State College Area School District  
Ferguson Township Elementary School  
**Preliminary Daylight Analysis**  
**October 1, 2009**

The purpose of this analysis is to determine the daylight performance of the design as of September 2009 and to provide performance recommendations.

First Floor Classrooms March 21st 12pm

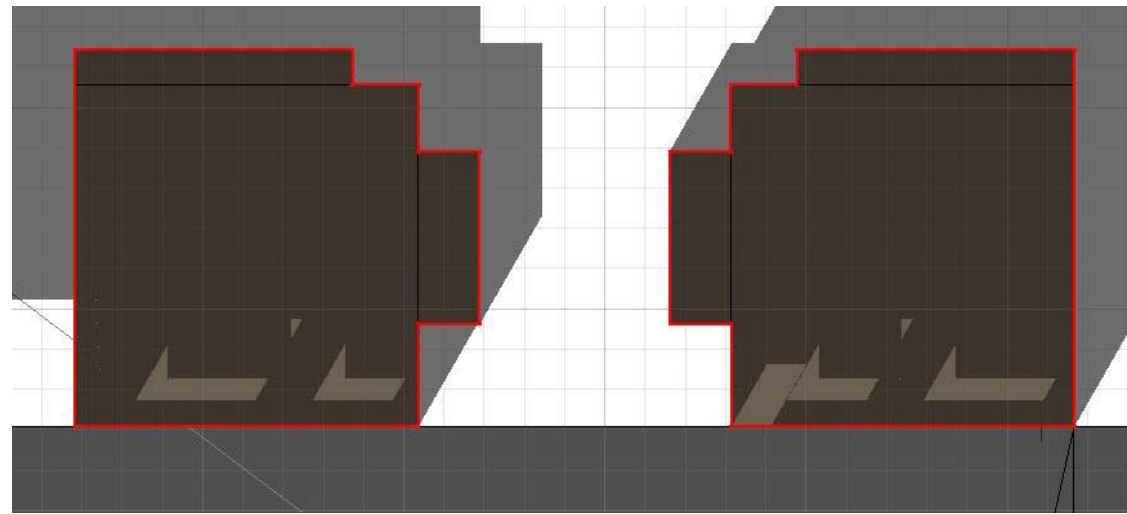
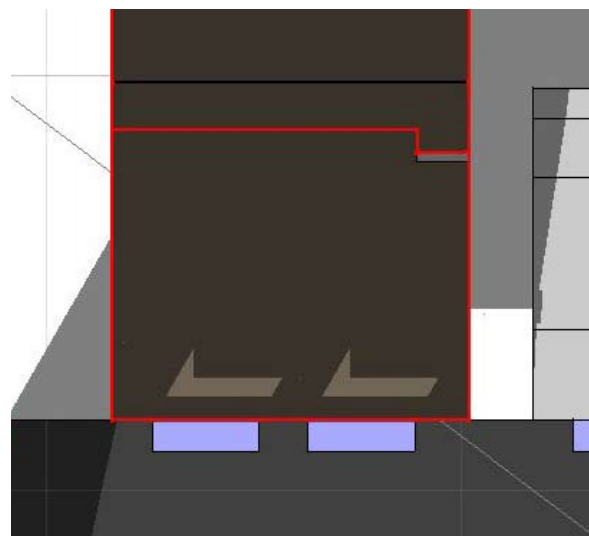
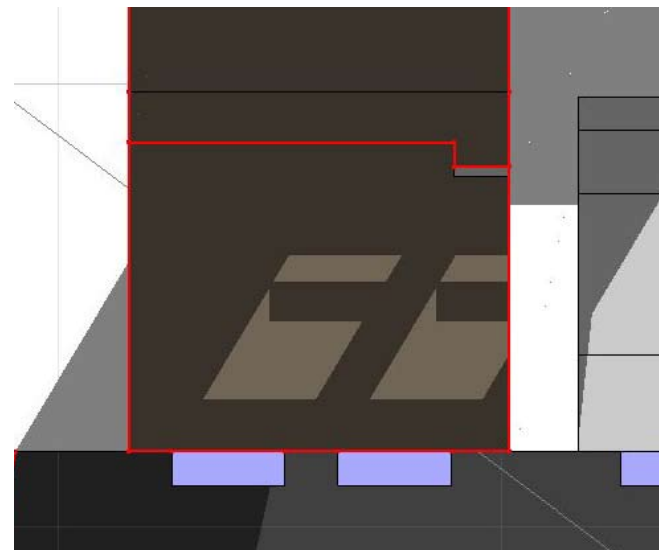
The project's orientation presents some situations that need responded to in a specific manner. The southern elevation of the classroom wing is orientated southeast. As shown in the image above, the exterior shading devices in their current size do not provide 100% shading for the classrooms.

As shown in the images above, the exterior shading device needs to extend beyond the western edge of the window. Direct solar will be an issue from 8am till 10am from March to June and August to October.

In the winter months, November to February, direct solar will be an issue from 8:30am till 2pm under clear sky conditions.

It is recommended that the exterior shading device extend at least 1'-6" beyond the western edge of the window. Because of the orientation, the shade does not need to extend beyond the window edge on the eastern side. This is due to low sun angles.

Blinds will be needed in both the view and daylight windows to control the direct solar issues that will occur during clear sky conditions in the winter months.

# 1st Floor South Facing Classrooms

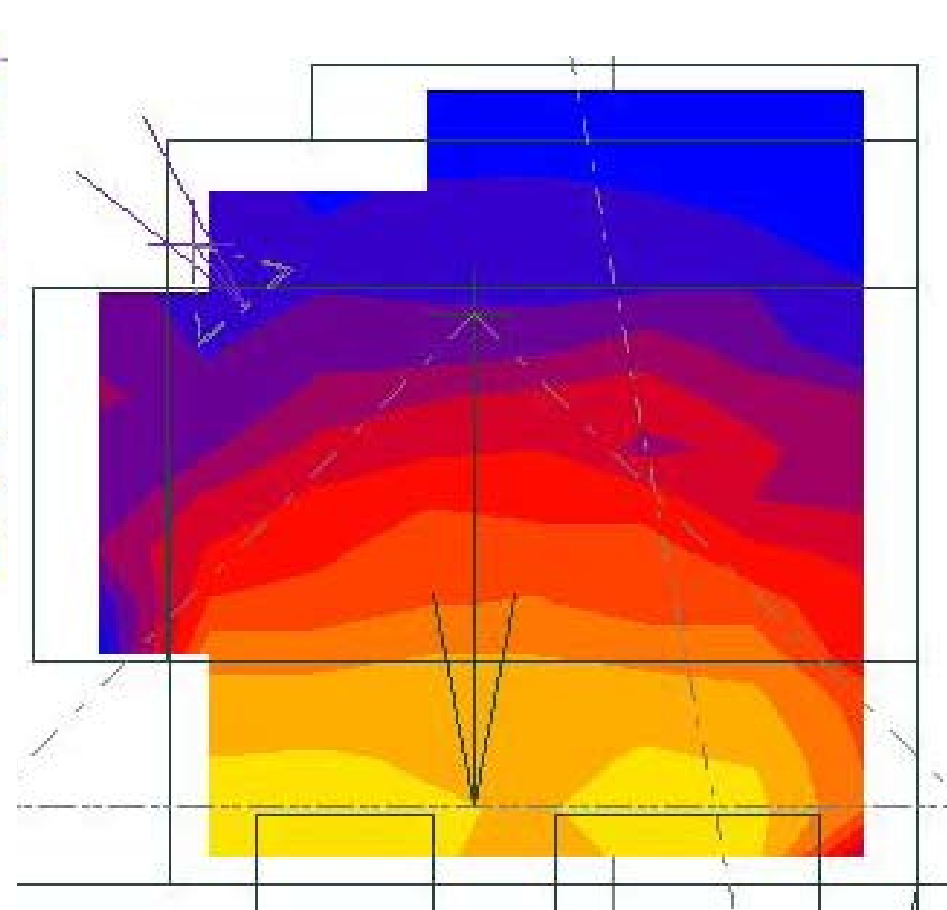
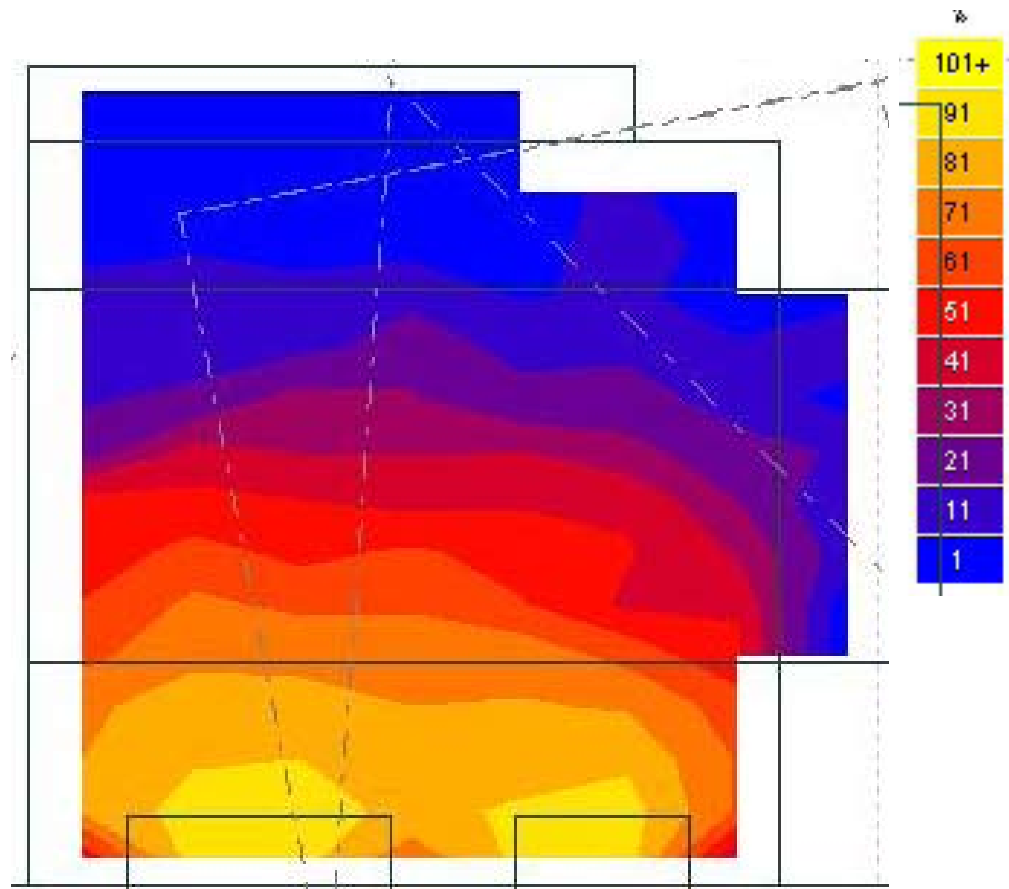
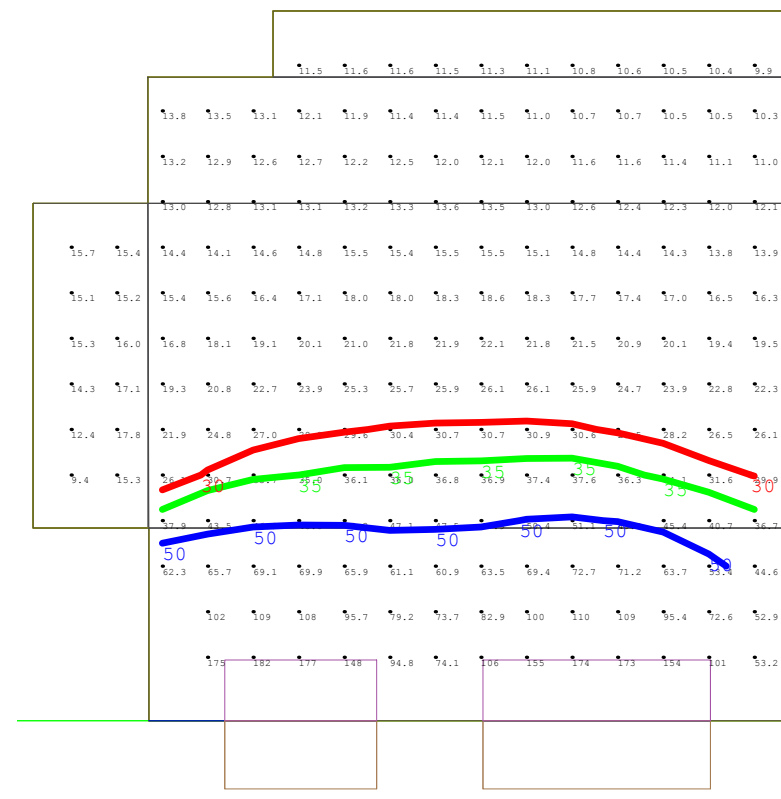
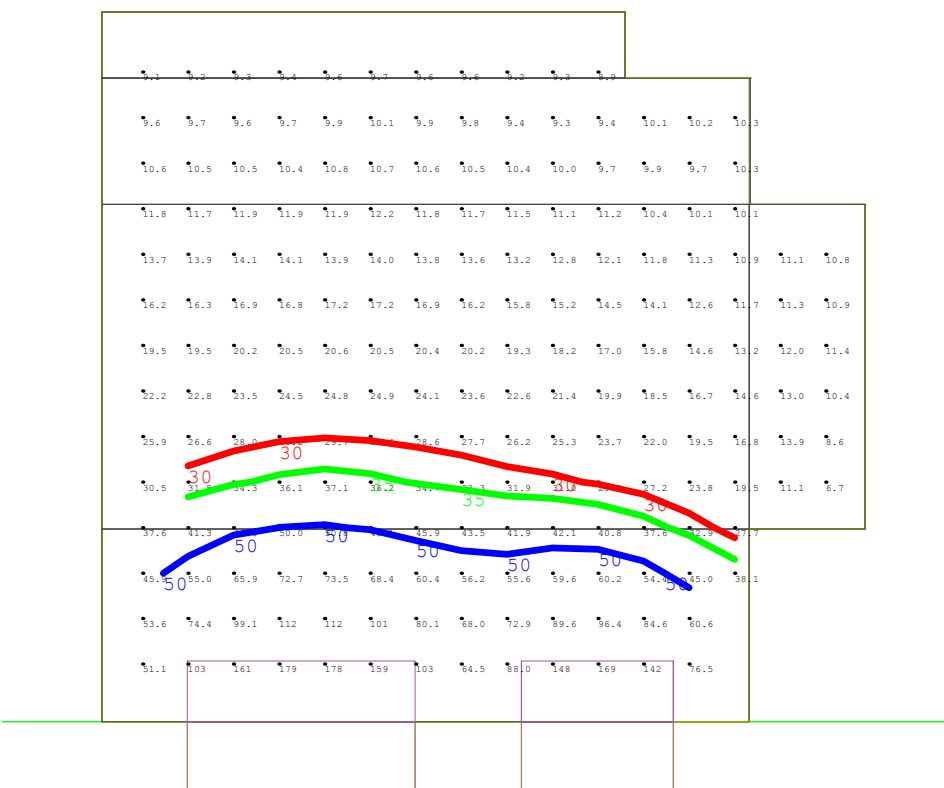
The classroom on the right was modeled with a door and the one on the left was not as a comparison. As shown in the DAR images, the targeted DAR is being met for at least 50% of the space. The bottom images are at 12pm on March 21 under overcast sky conditions, which is the worst case scenario. Those snap shot images help validate that only 50% of these spaces are meeting the target levels.

The optimal scenario is to have a view window of 60% with a SHGC around .3 and a daylight window of 70%. If for budget reasons, the glazing must be the same for each window, it is suggested that a VLT of 70%, +/- 2%, with a SHGC of around .35. A higher VLT will not hurt since the window is being shaded.

The exterior shading devices should be no less then 3'-0". The only means by which this could happen is if it is angled. Further simulations would be needed to validate performance. The shading device should have an openness value of 30-35%, see sample page at back of report.

The interior light shelf needs to be no more then 2'-8" in length from the glazing. The thinner the shelf the better, Any shelf greater then 2" in thickness should have an angled bottom surface.

Electrical lighting should be installed to compliment the daylighting. Based upon the analysis , the lighting should be parallel to the window wall. The first row should be on a sensor, the second and third rows should be at least dimmable or stepped switched.

Interior shades such as Meco should be used on both the daylight and view windows. Shades should be installed to work from the bottom up in the view window.

# 1st Floor North Facing Classrooms

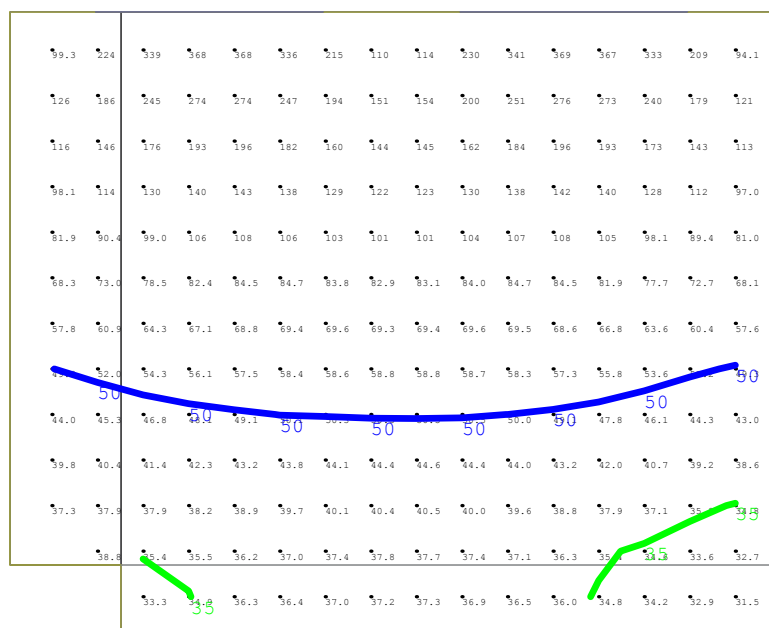
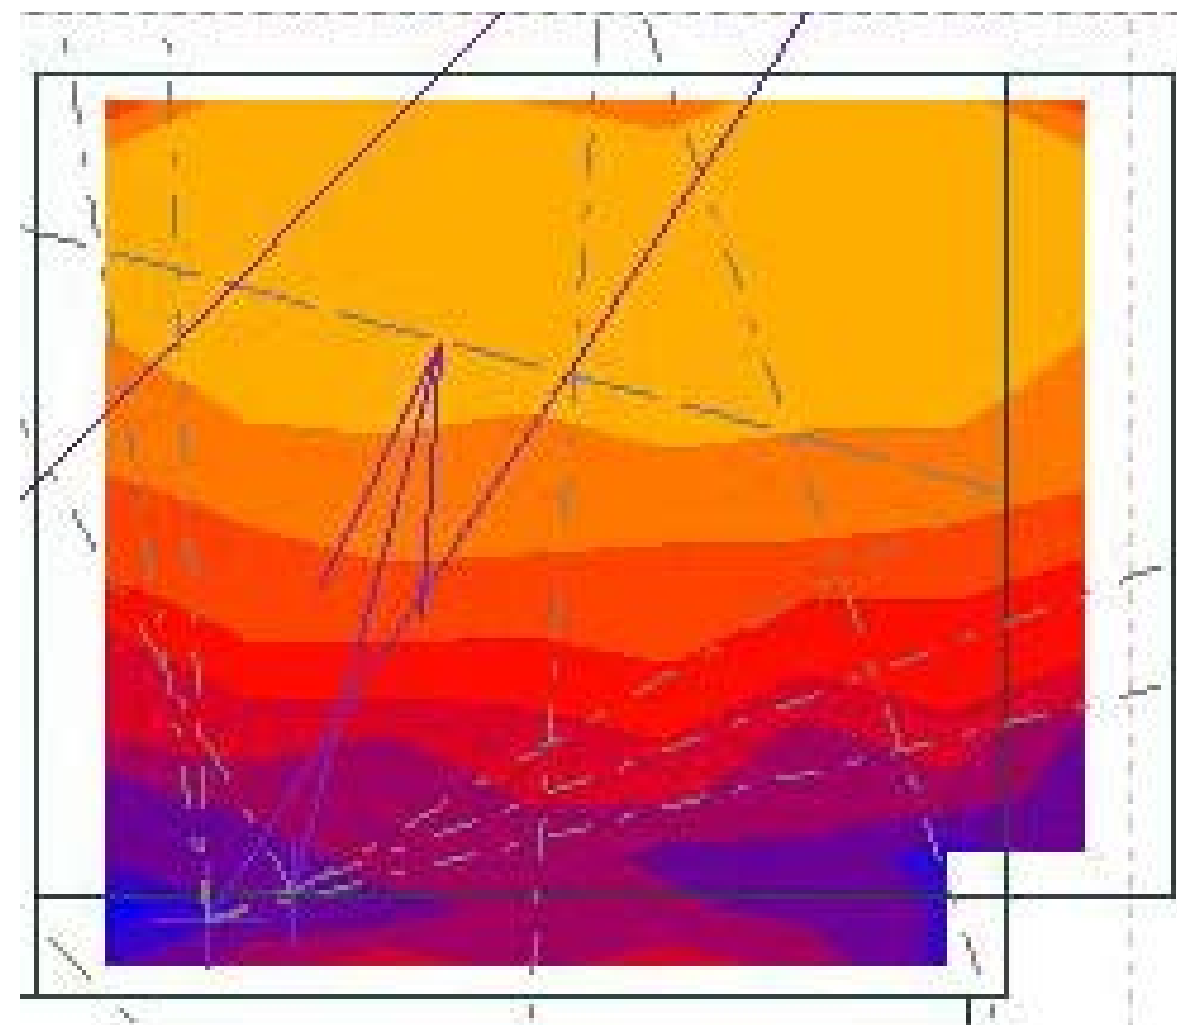
The targeted DAR is being met for almost 75% of the space. The smaller luxor image from March 21 under overcast sky conditions validates the illuminance levels.

The window to floor area could increase slightly; it is currently at 11% and could go as high as 15%. A VLT of at least 70% should be used and the SHGC should be no more than .45.

The electrical lighting should be run parallel to the window wall and each row should be stepped switched.

Shades will be necessary due to some probable glare issues.

## 2nd Floor South Facing Classrooms

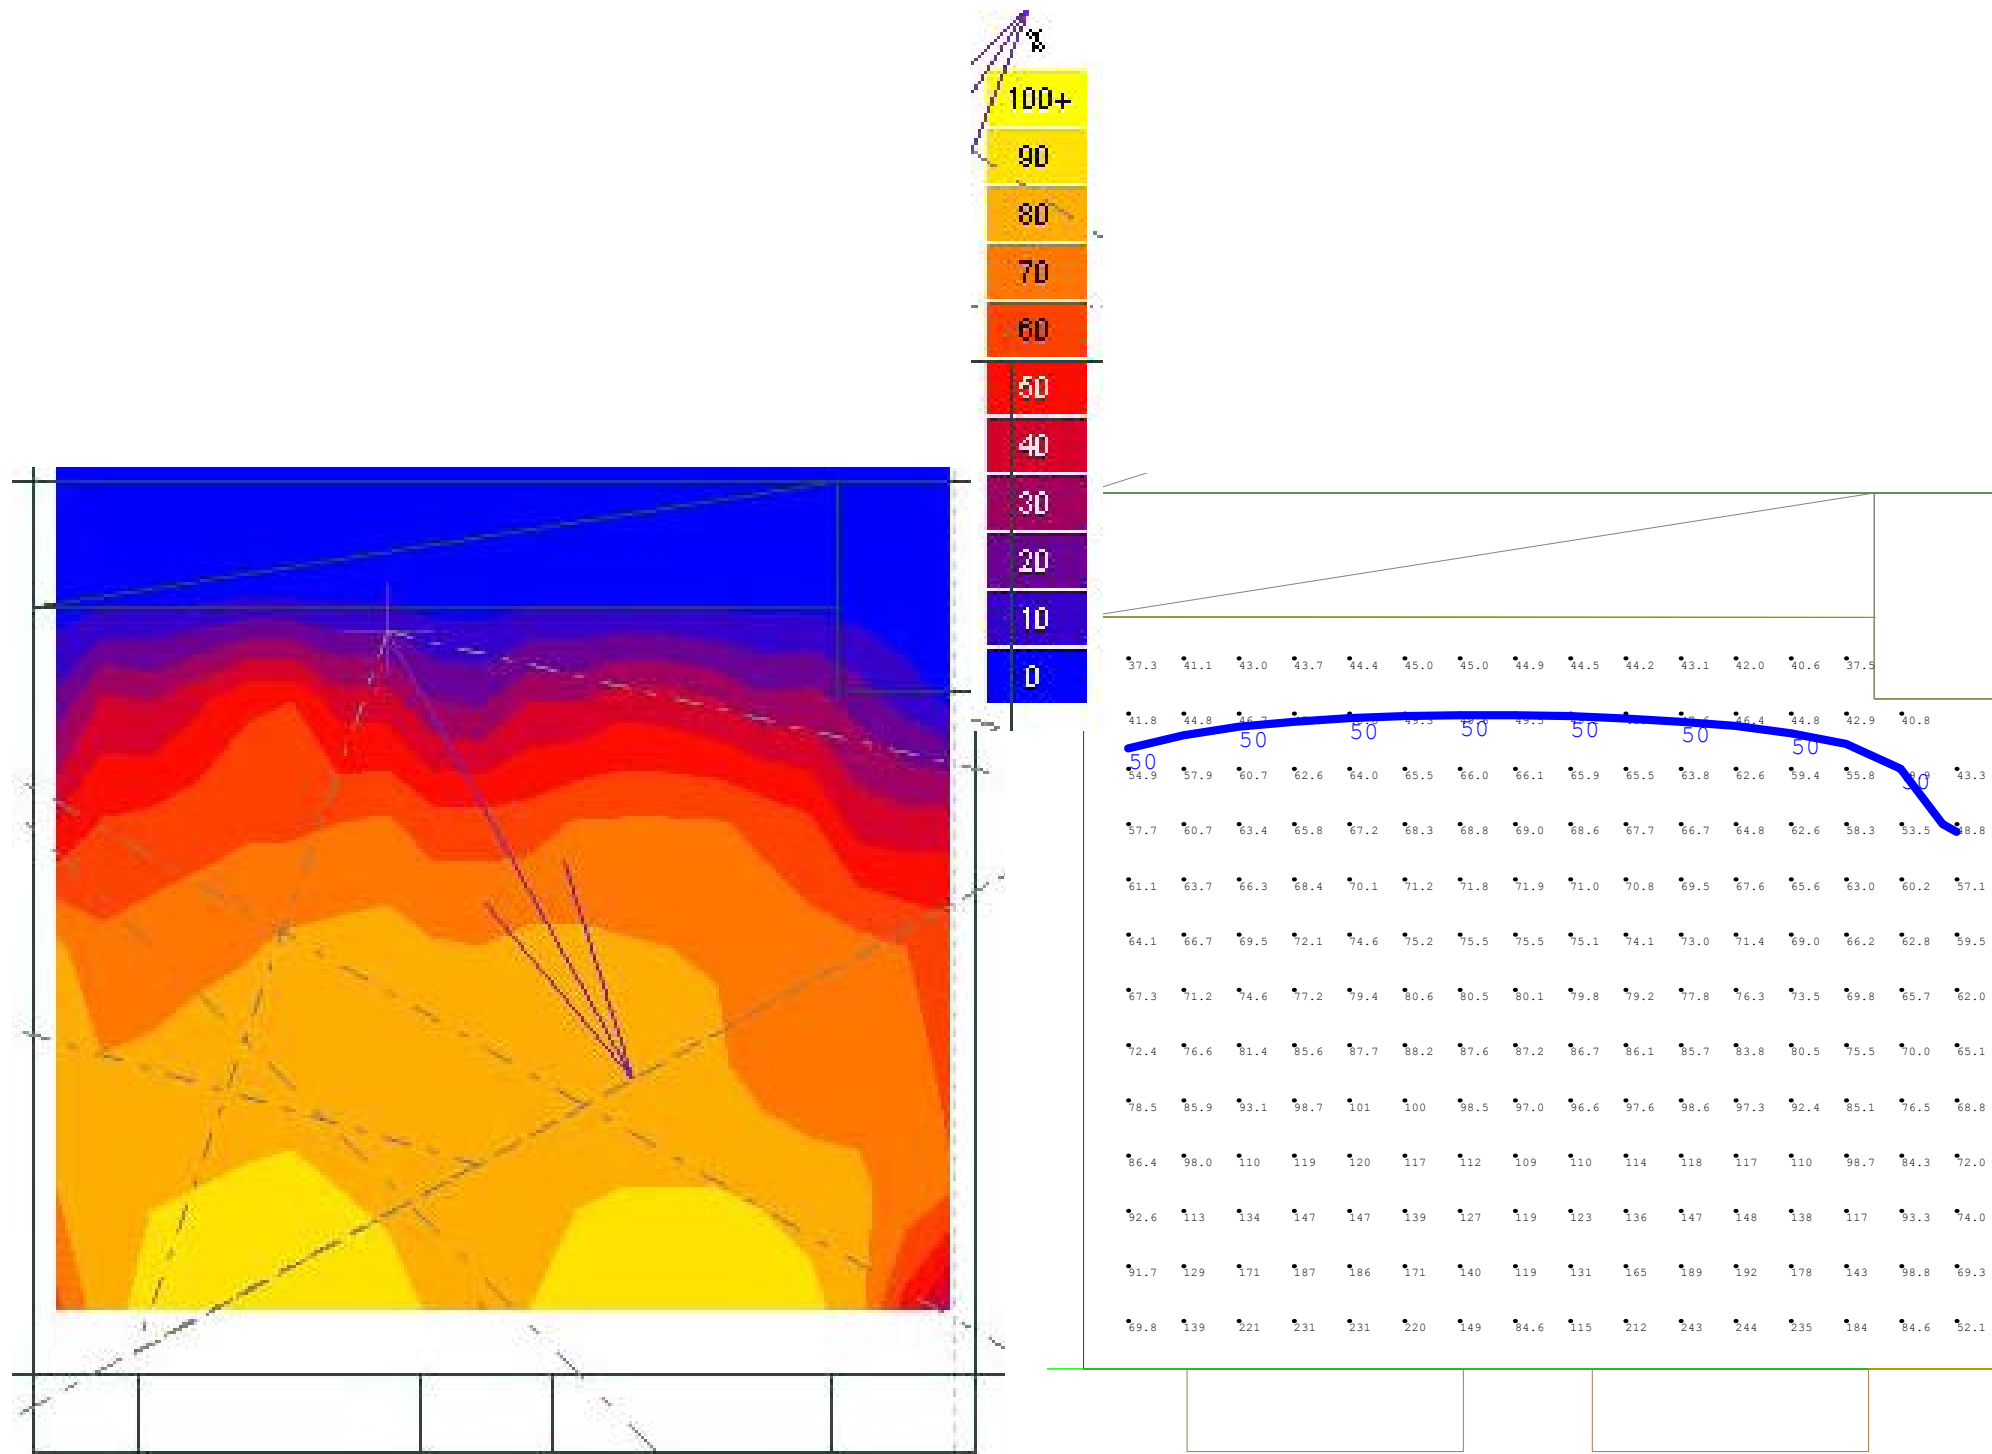
The largest portion of the space is meeting the target DAR. This due to the bilateral daylighting condition.

The optimal scenario is to have a view window of 60% with a SHGC around .3 and a daylight window of 70%. If for budget reasons, the glazing must be the same for each window, it is suggested that a VLT of 70%, +/- 2%, with a SHGC of around .35. A higher VLT will not hurt since the window is being shaded.

The exterior shading devices should be no less than 3'-0". The only means by which this could happen is if it is angled. Further simulations would be needed to validate performance. The shading device should have an openness value of 30-35%, see sample page at back of report.

Electrical lighting should be installed to compliment the daylighting. Based upon the analysis and a bilateral daylighting condition it would be feasible to have the first two rows dimmable with a daylight sensor and the third row be stepped switched.

Interior shades such as Mecos should be used and installed to work from the top down.
